TOWN OF COVENTRY, RI
 DEPARTMENT OF PLANNING & DEVELOPMENT

STAFF REPORT

Project Name:	Dante Real Estate II – Tiogue Ave.
Plan Type:	Unified Development Review (Major Land Development w/ associated Dimensional Variances)
Plan Review Phase:	Master Plan with a request to combine with Preliminary Plan stage
Owner:	Dante Real Estates
Applicant:	Mike Saccoccia
Address:	0 Tiogue Ave.
Plat / Lot / Zone:	AP 28 Lot 49 Zone GB Lot Size 3.83 acres
Existing Use:	Vacant
Proposed Use:	Commercial Equipment Storage Facility for Contractor Use
Description:	Applicant proposes to construct a 10,000 SF commercial equipment storage facility for contractor use building with associated landscaping and parking. In addition, the applicant is seeking Dimensional Variances for having less than the required 50' vegetative buffer on the eastern side of the property, for having access too close to another driveway, and for the building design elements proposed for this site which is located within the Special Planning Overlay District. This project will be reviewed under Unified Development Review in which both the Major Land Development and the Dimensional Variances will be decided by the Planning Commission.

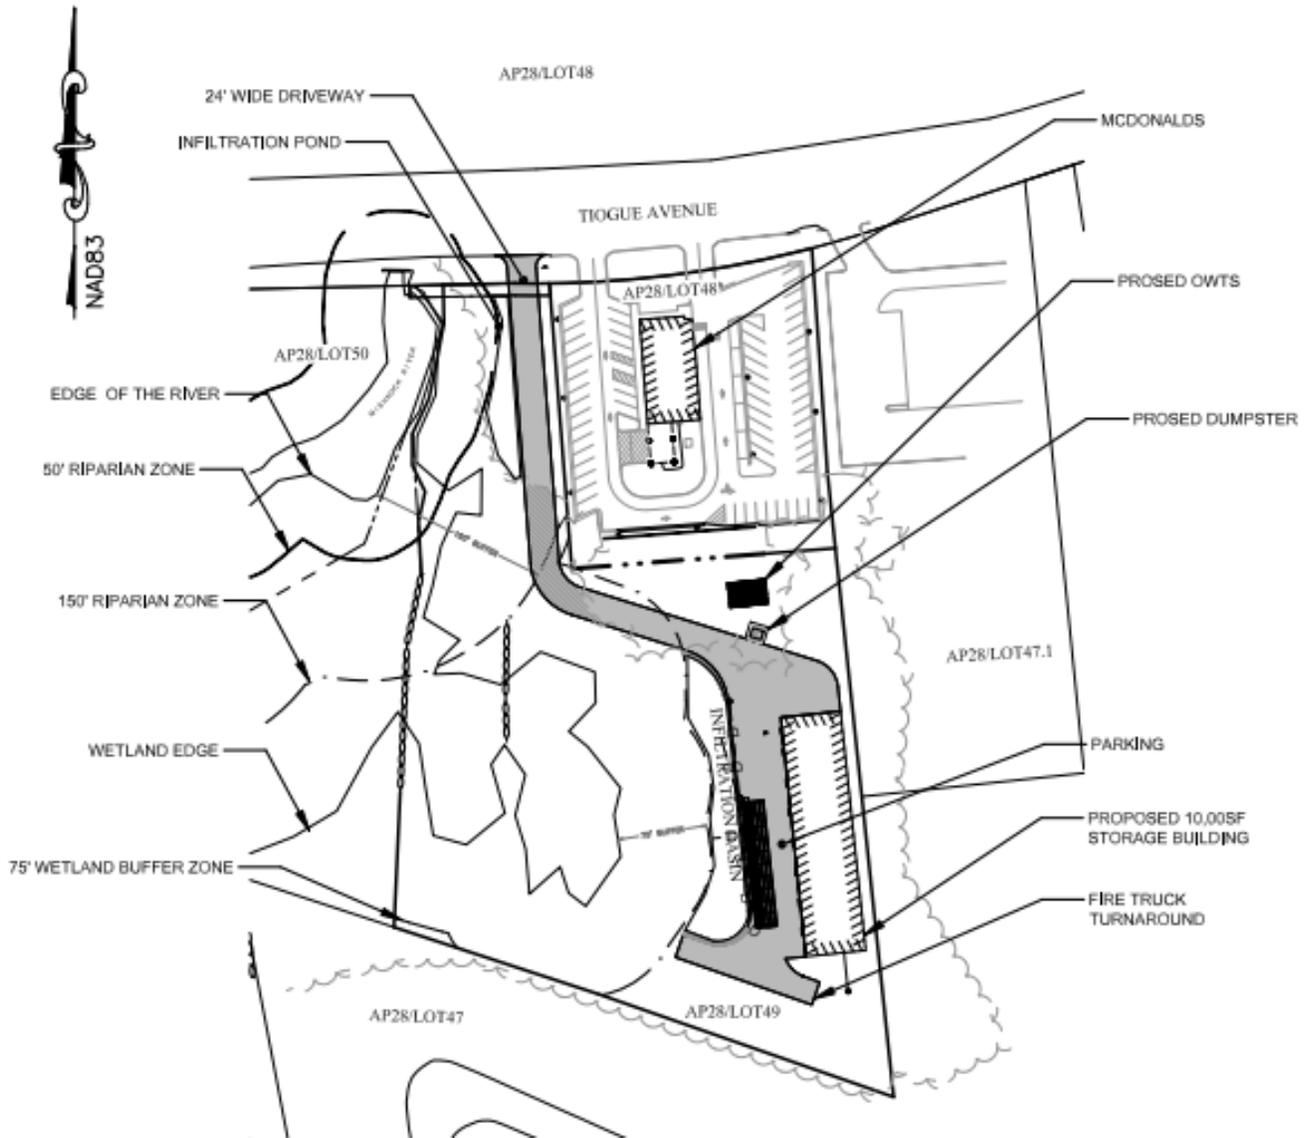
The subject parcel is located on the southern side of Tiogue Ave., behind the McDonald's at 1100 Tiogue Ave. (Lot 48), in the GB zone. To the west are wetlands, to the south is a Mobile Home community, and the parcels to the north and east are business uses. It is worth noting here that the above map is slightly out of date as there has been an administrative subdivision that has adjusted the southern lot line of Lot 48 north so that there is no longer a jog, i.e. the current southern lot line of Lot 48 runs straight across. This is shown on the proposed conditions plans.

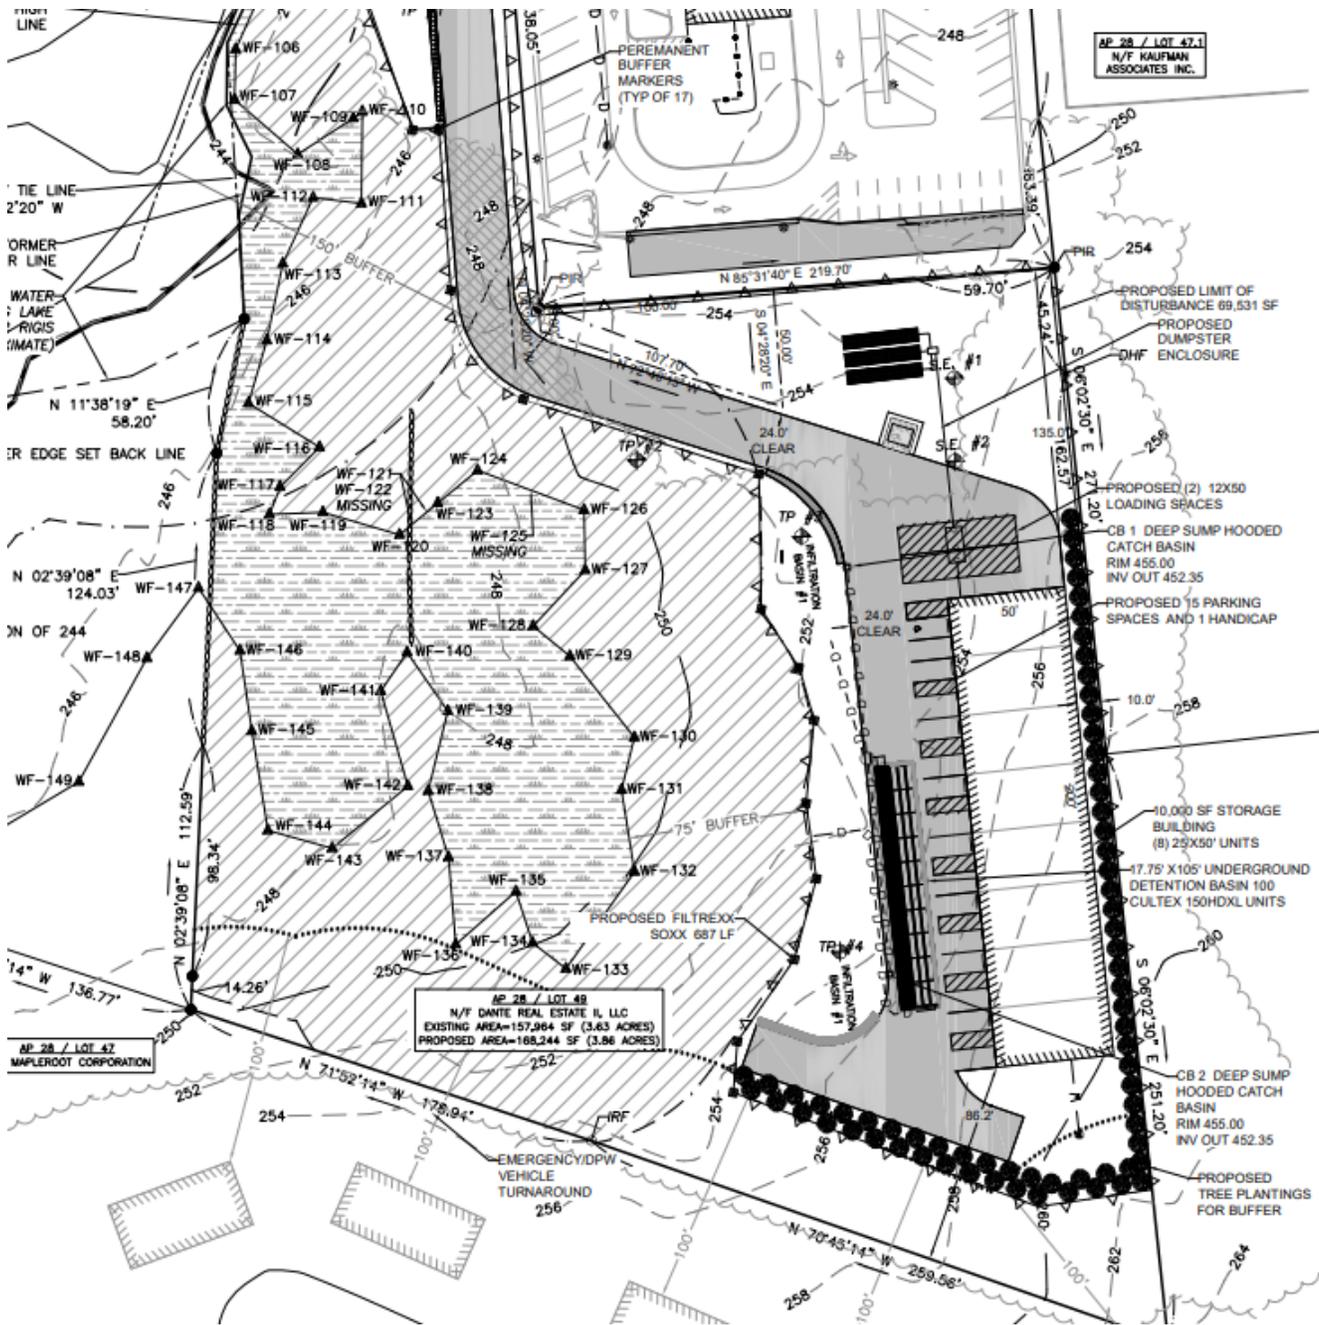
Due to the presence of wetlands on the western side of the property, the applicant's design of the site pushes the building and parking to the east. This easterly shift means that the 50' required buffer (§ 255-1730A) is not realistic, with only 10' from the proposed building to the property line. The applicant has proposed a row of new planted trees as a buffer mitigation on the easterly side. Staff recommend Arborvitae or similar screening. Please note that while the trees on the eastern side of the proposed building are only shown on the Site Plan (page 4 of the plan set), we have confirmation that the applicant will add them to the full Final Plan plan set.

The flag shape of the lot requires that the design locate the proposed driveway 18 feet from the existing driveway of the McDonald's just to the east. § 255-1230E requires 150 feet between access points of a commercial or industrial use on an arterial street. It is the opinion of Planning staff that the proposed driveway can't be moved any further west due to the wetlands. In addition, the proposed use will create minimal traffic further reducing any potential conflicts. Both the Central Coventry Fire Department and the Coventry PD were consulted on this driveway location and both had no comment.
